# Work Order ID 91678

Item Name: Replacement Skidtube

DRAWING NO. D2590	TITLE 204 SKIDTUBE ASSEMBLY	REV. E	DART AEROSPACE LTD ENGINEERING ORDER		D.E.O. NO. D2590-E-1	SHEET NO. SHEET 1 OF 1	SCALE NTS
DRAWN <i>qp</i>	CHECKED <i>ASS</i>	MFG. APPR. <i>RE</i>	APPROVED <i>MP</i>		DE APPR. <i>MP</i>		
DATE 11.12.13	DATE 11.12.13	DATE 11.12.13	DATE 11/12/13		DATE 11/12/13

CHANGE ALL WELDED CROSSBOLT SPACERS TO SWAGED SPACERS

**SECTION B-B & F-F**  
NOT TO SCALE

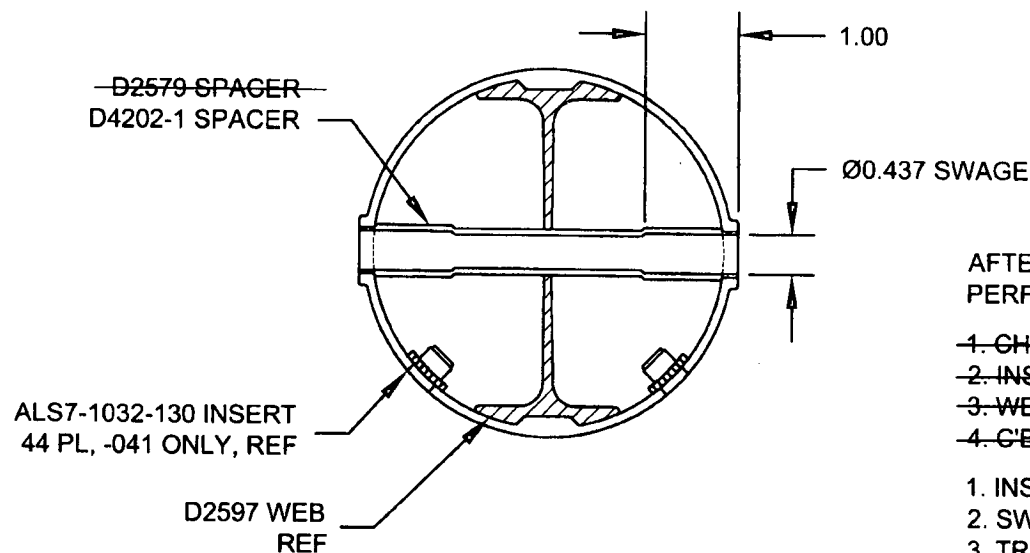
WAS

QTY	QTY	PART NUMBER	DESCRIPTION
-041	-043		
17	22	D2579	CROSS BOLT SPACER

SECTION B-B & F-F IS AMENDED AS FOLLOWS:

1. CHAMFER HOLE 0.050 X 45°
  2. INSERT D2579 SPACER (17 PLACES)
  3. WELD INTO PLACE AND GRIND FLUSH
  4. C-BORE D2579 SPACER TO Ø0.437 X 1.00 DEEP
1. INSERT D4202-1 SPACER, 17 PL
  2. SWAGE TO Ø0.437 X 1.00 DEEP PER QSI 002
  3. TRIM / GRIND FLUSH PER QSI 002

IS

17	22	D4202-1	SPACER
----	----	---------	--------
